From: [REDACTED]
To: [amendments](#); [Preston Market](#)
Subject: Preston Market Submission
Date: Monday, 12 July 2021 3:04:04 PM
Attachments: [Preston Market submission.pdf](#)

DRAFT DAREBIN PLANNING SCHEME AMENDMENT C182

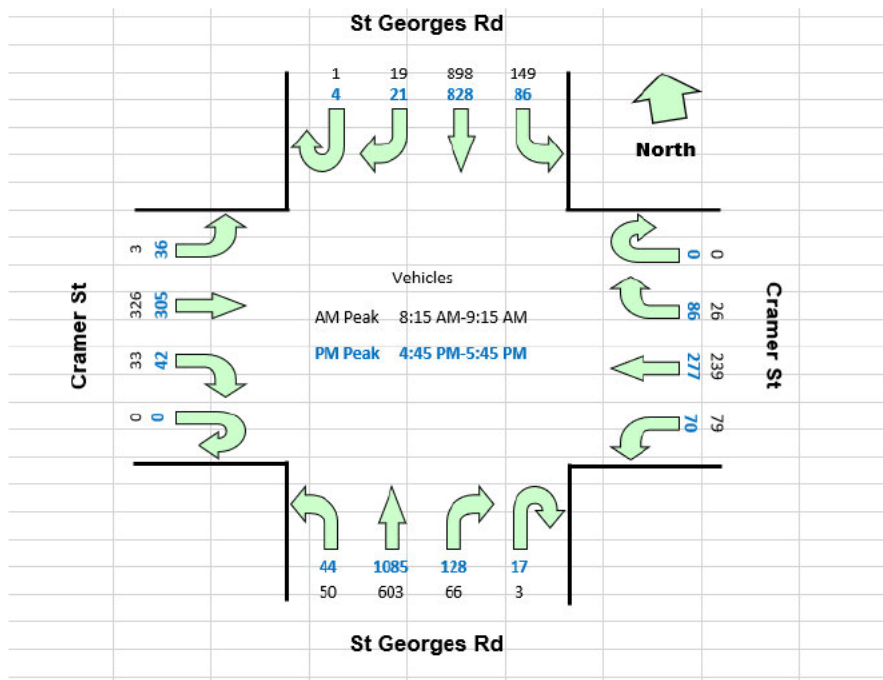
The traffic implications of the proposed intensive redevelopment of the Market Precinct on Mary Street between Cramer Street and Bell Street has not been considered.

Under any scenario, the outcome is that the part of Mary Street which I live on is likely to carry much more traffic than it does at the moment. Mary Street between Bell and David streets is not designed to carry two way traffic with parked cars. The increase in traffic volumes will exacerbate the existing situation.

A suggested solution is for Mary Street to be made one way between Bell and Cramer streets and for works to be funded through the proposed DCP. This would also allow for widening of footpaths and planting of more substantial canopy trees to enhance the amenity for the 4,500 to 6,000 new residents who will call the Market Precinct home and will use the surrounding streets as pedestrians and cyclists.

Council traffic count taken on a Thursday in August 2019

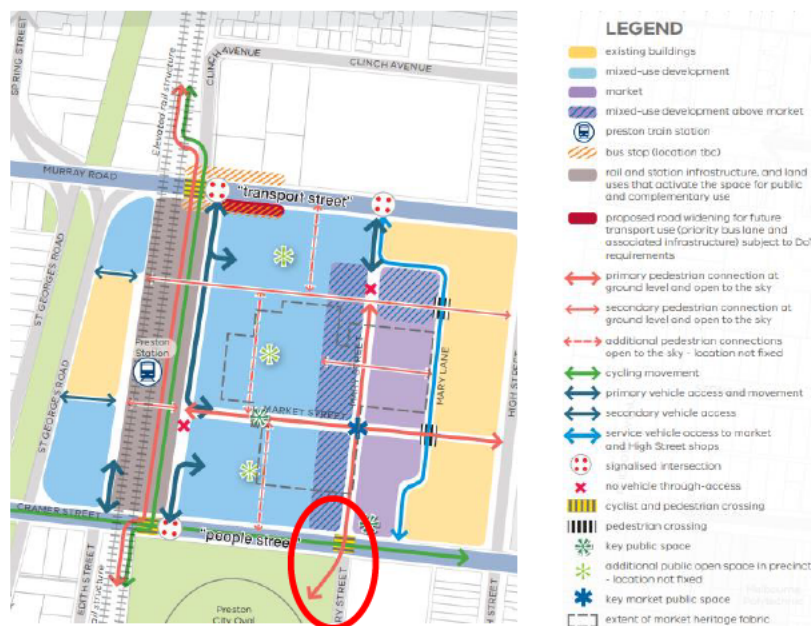
At peak, Cramer Street adjacent to the Market Precinct carries approximately 500 vehicles per hour in each direction. To this will be added traffic movements associated with 2,200 dwellings and up to 1,400 workers. The realisation of a 'people street' rather than a 'transport street' is going to be a challenge.

Cramer Street human scale

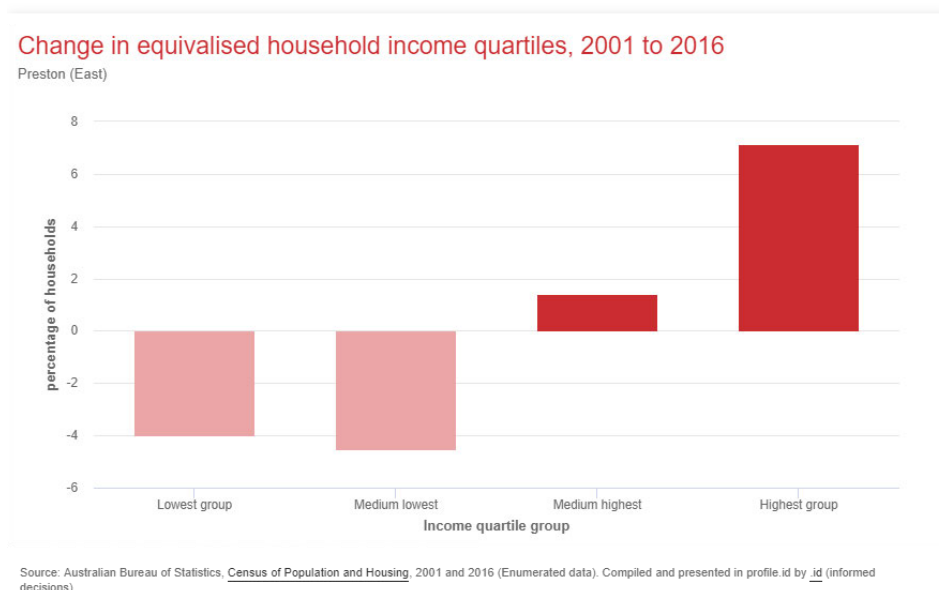
The preferred maximum building heights within the draft ACZ Schedule provides for 42 metre high buildings with a streetwall height of 12.1 metres, and a setback above the streetwall of 5 metres.

My submission is that this streetwall height is too high, the setback above the streetwall is inadequate and the building height for this part of the Market Precinct is too high. It also concerns me that there is no streetwall requirement to the Cramer Street frontage between Mary Street and Mary Lane.

A streetwall height of two storeys with a more substantial setback to upper levels, for the length of the Market Precinct east of the railway line would create a more human scale for the 'people street'. Likewise, a maximum building height of 8 storeys for the southern third of the Market Precinct is preferred, particularly given the long range views of new buildings on this part of the site from the park opposite.

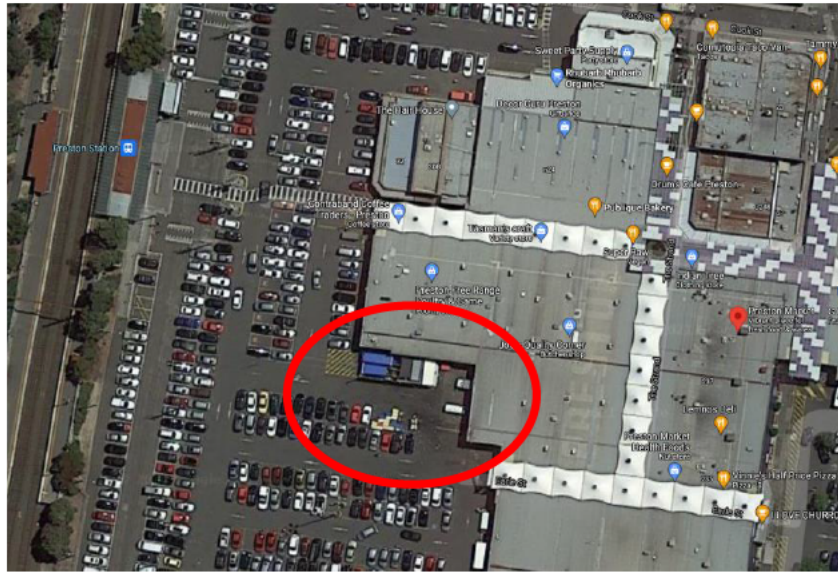
The proposed ACZ Schedule includes a requirement that development must not overshadow more than 75% of the key public spaces within the precinct between the hours of 11am and 2pm on 21 June. This is a mandatory requirement which cannot be varied. There are two key public spaces shown on the Framework Plan. There is a third public space which is arguably key, labelled on the Framework Plan as 'Key market public space'.

For clarity it is suggested that consistent terminology be used between the Framework Plan and the ordinance. All three of these spaces are non-specific in their location, dimensions and size, which is significantly problematic in applying a mandatory control.

This is exacerbated by the staged nature of the development. For example, what if buildings are approved on the north side first, before any public open space is approved and then the horse has already bolted for provision of solar access to that space.

All key public spaces should be shown at a specific size, dimensions and location on a map within the ordinance. For the same reasons as discussed above, these key public spaces should not be overshadowed for the 5 hours between 10am and 3pm on 21 June. Sunlight in public spaces within the market and the broader precinct, throughout the day and throughout the year, are central to the environment created.

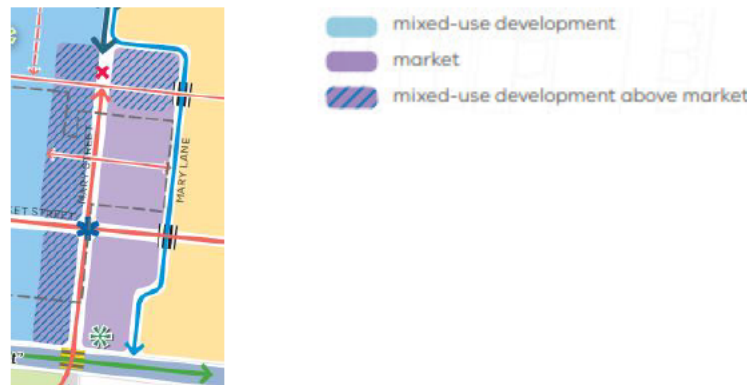
A visit to the part of the current market circled on the aerial below, on Saturday or Sunday afternoon in Summer reveals the extraordinarily gag-worthy stench of the waste from meat, poultry and especially from seafood. This smell is associated both with bins and also stagnant pools of water from hosing out stalls, including seafood ice, at the end of each trading day.

The ACZ Schedule should be amended to specifically require information about how market waste and cleansing is required to be managed in order that residential apartments and market uses can operationally coexist as they are not easy bedfellows.
